**PERMIT
 INDEXED
 TAX ID #05-367093**

**ON-SITE SEWAGE DISPOSAL SYSTEM
 HOWARD COUNTY HEALTH DEPARTMENT
 BUREAU OF ENVIRONMENTAL HEALTH**

ADDRESS: 7177 Pindell School Road PROPERTY OWNER: George Fambro

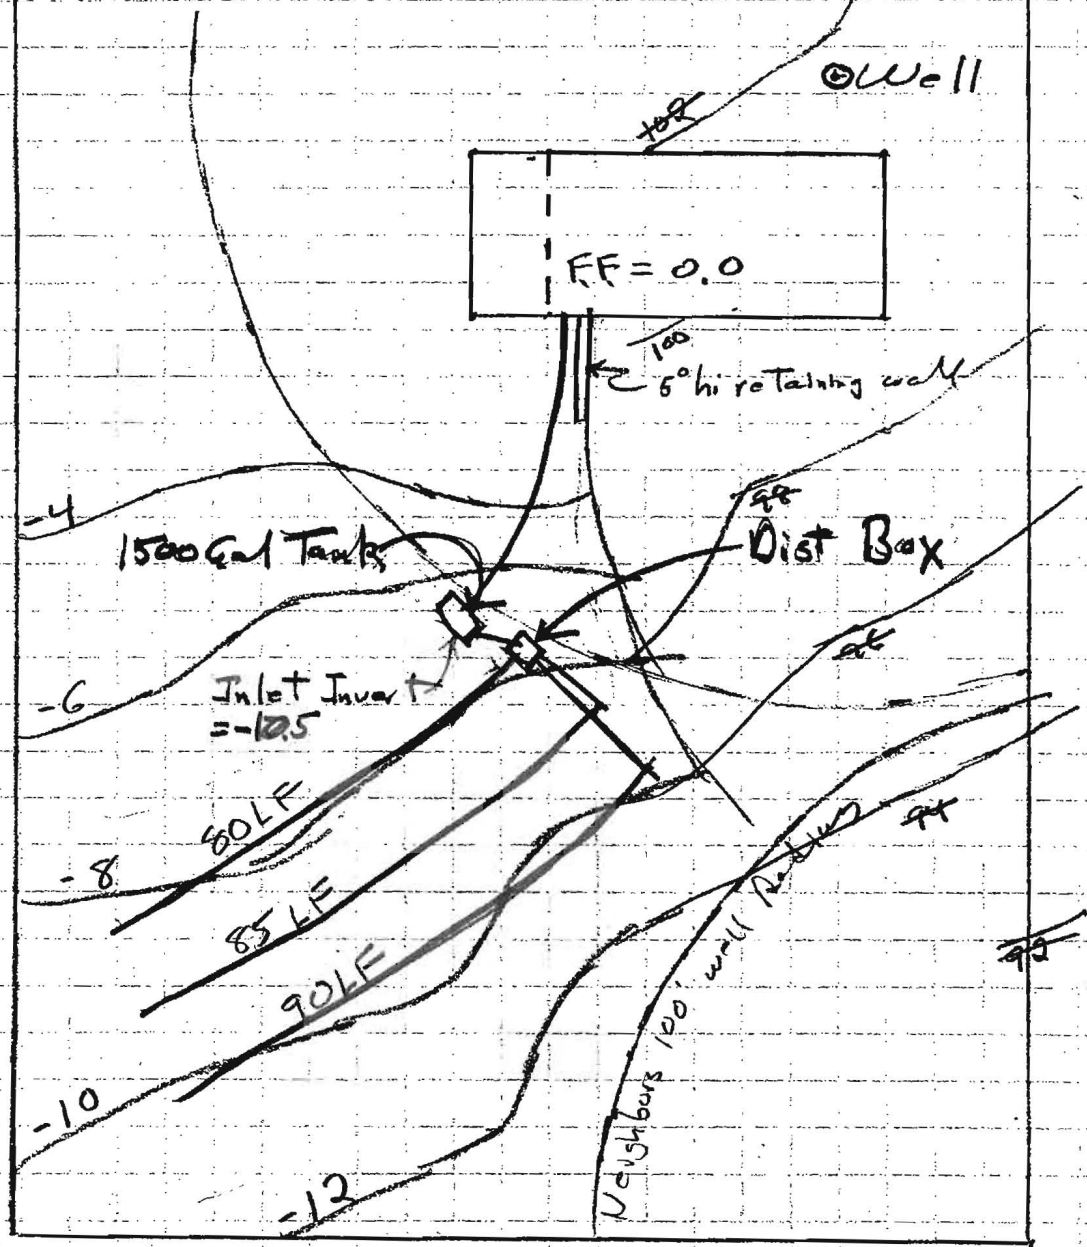
*Inlet 4'
 Depth 9.5'
 2' Wide*

PRE-CONSTRUCTION 5/23/05 Dug perc test hole to 14' depth near old test hole A. Poured water in bottom of hole and had INSTALLATION a 2+ minute per inch rate. Changed trench specs. in order to save room for future repairs. Could not install trenches as originally proposed. (BB) Trenches installed as per change in specs. 2' short of required, due to surrounding well radius's & property lines. Number of bedrooms should never exceed 3.

TRENCH/DRAINFIELD DATA		
WIDTH	INLET	BOTTOM
2	4	9 1/2
NUMBER OF TRENCHES		2
TOTAL LENGTH		120
ABSORPTION AREA		
DISTRIBUTION BOX LEVEL		✓
DISTRIBUTION BOX BAFFLE		✓
DISTRIBUTION BOX PORT		2
